SERVICE BULLETIN # 1079

SUBJECT **HANDLE BRACE BOLT**

MODEL **1-40**, 1-50, 1-60 DATE 12/15/59

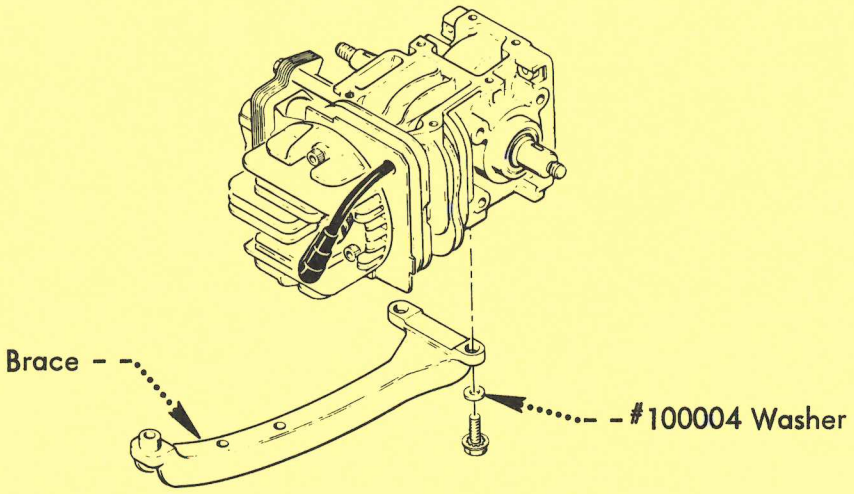
If the Handle Brace Bolts, P/N 100882, are bottoming out in the crankcase cylinders of Models 1-40, 1-50, and 1-60 saw engines, add a plain Washer, P/N 100004, under the head of each Handle Brace Bolt.
